STERLING RANCH - MARKSHEFFEL ROAD

STREET IMPROVEMENT PLAN

CDR-20-005

Engineering Review
10/30/2020 10:39:18 AM
JDR/djrice
JeffRice@elpaso.co.gov
(719) 520-7877
EPC Planning & Community
Development Department

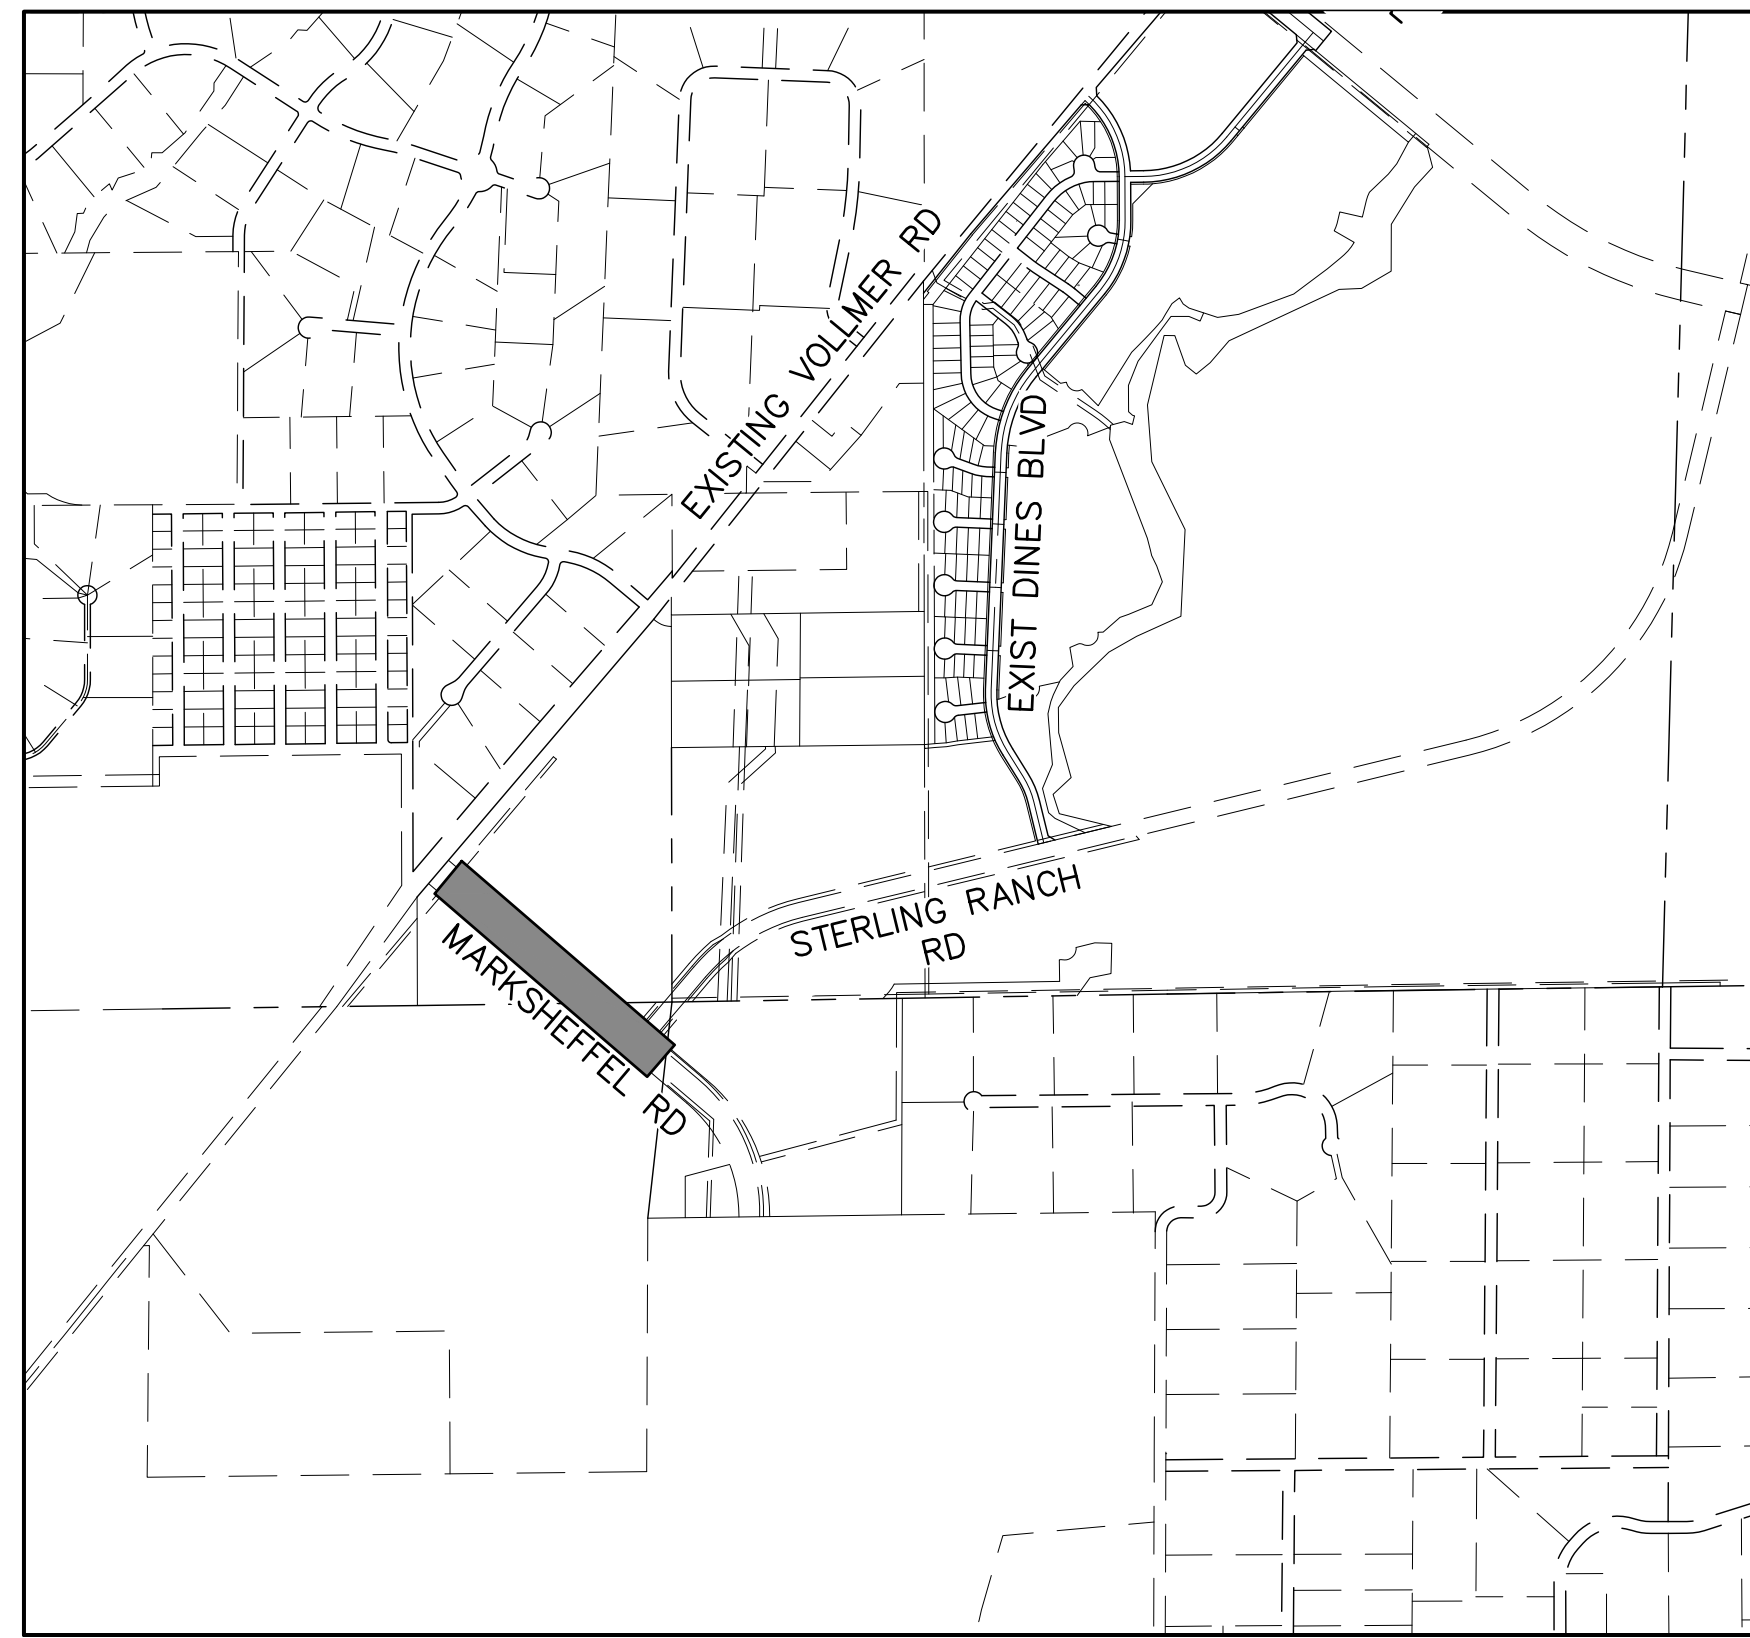
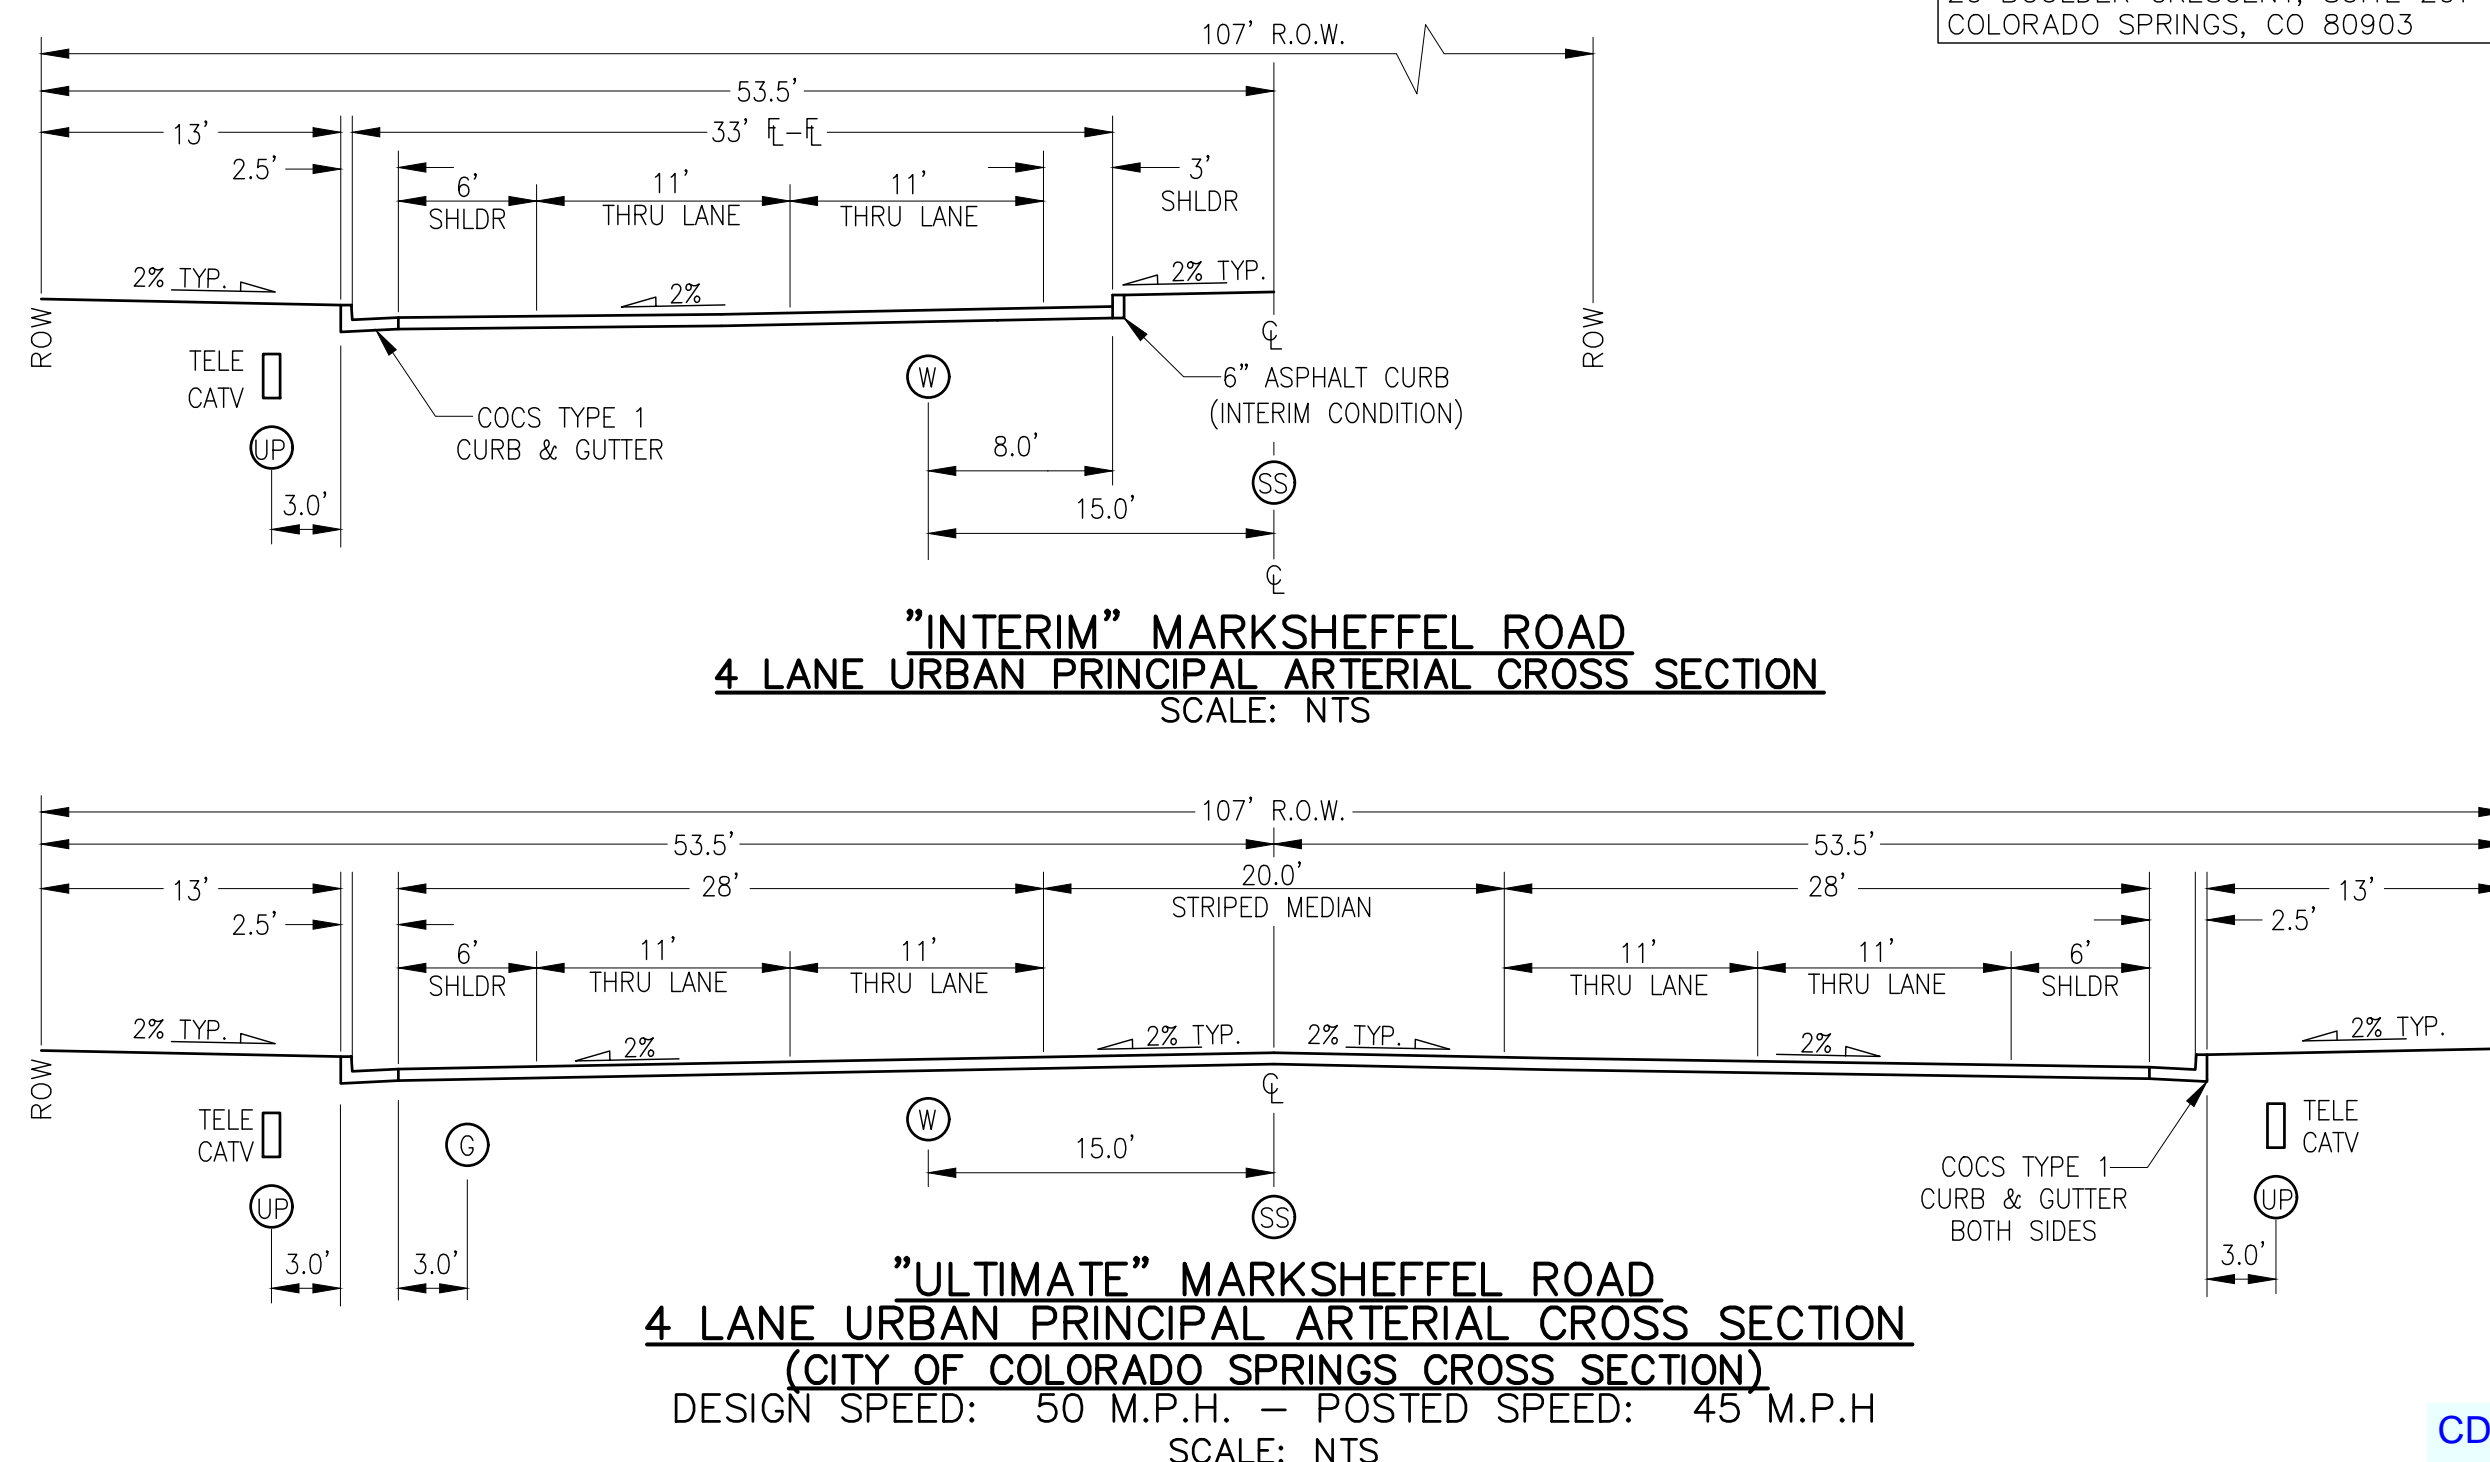
See comment letter also.

Per notations, Filing 2 storm drain construction needs to be approved and constructed prior to these plans.

See City comments.
